ENERGY STAR Program Requirements for Servers 1.0 – Draft 3 – Comments from the ECESB Technical Working Group

We present in the following a summary of comments from the European Community Energy Star Board Technical Working Group (ECESB WG) on ENERGY STAR Program Requirements for Servers 1.0 – Draft 3. The comments are public.

Fig. Relationship between on_max, rated PSU power etc.

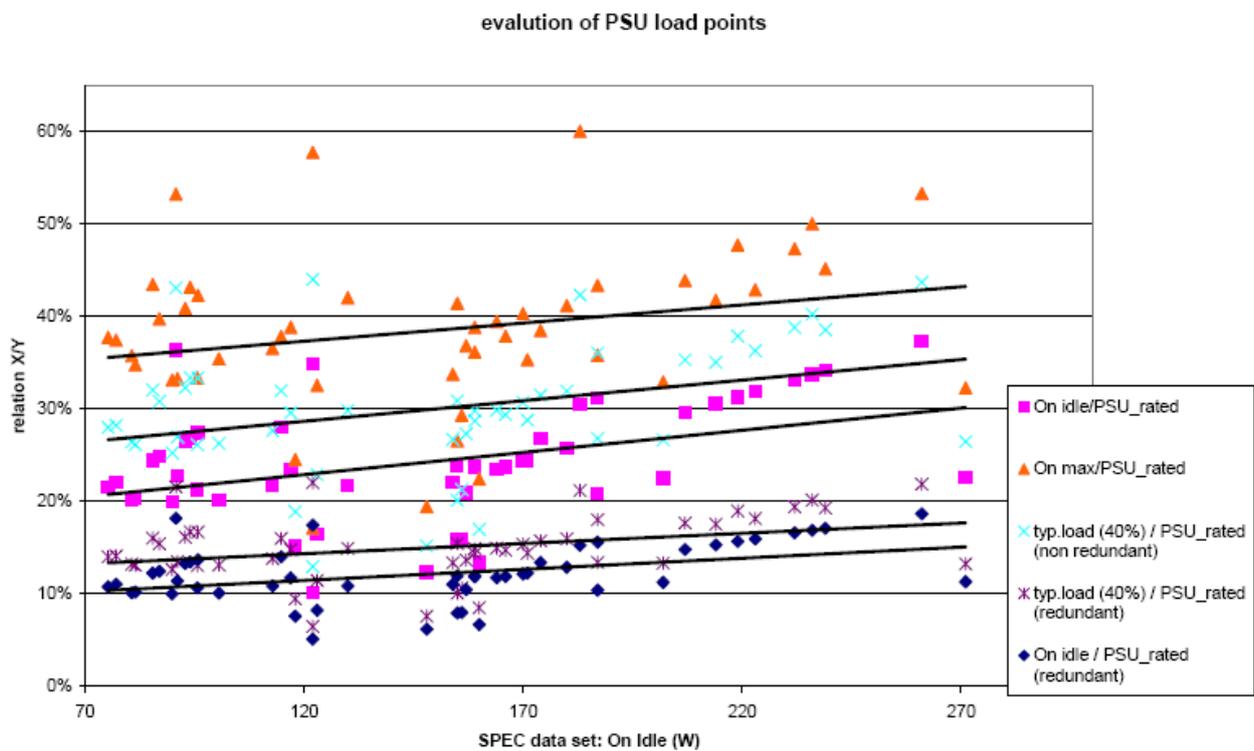
To avoid a disadvantage for small power supplies 20 % requirements may be implemented from minimum PSU size upwards (see also further below). On the other hand we think that there is little relevance in testing efficiency at 100 % power load since this level will rarely be encountered in practise. It may be more practical to introduce a 75 % load level and to skip the 100 % level . Overall it would seem appropriate not only to address PSU efficiency but also to try to cover right sizing of PSUs in some way.

Calculations for typical server configurations (modified data from SPECpower) show that max power (at maximum workload) is often only 45 – 50 % of max rated PSU power (non-redundant situation). In case of redundancy the gap between maximum rated power and maximum required power is even bigger. However, in any case the PSU needs to be oversized compared to the on mode due to more power drawn at start up.

It is sometimes argued that power supply capacity must meet power demand also for high configurations of servers and consequently in case of upgrading. Alternatively different sizes of power supplies for different configurations could be offered. Since manufacturers offer online tools for server configuration an adequate sizing of the power supply should be possible. For the moment the major problem is the limited availability of different sizes of power supplies especially in the low-end power segment.

The following potential approaches, which could provide an incentive to avoid oversizing of power supplies could be considered for future tiers:

- Defining a maximum ratio of PSU rated power and max active power at full work-load and typical (and high) configuration.
- Introducing an additional size class for power supplies. Additional power supply classes may be introduced (e.g. <400W, 400–1000W, >1000W) and 10 % requirement would not be valid for the low-end class (smallest power supplies) but only for the other classes. Thus small power supplies would have no 10 % requirement since they anyway will be operated at higher power loads in practice.
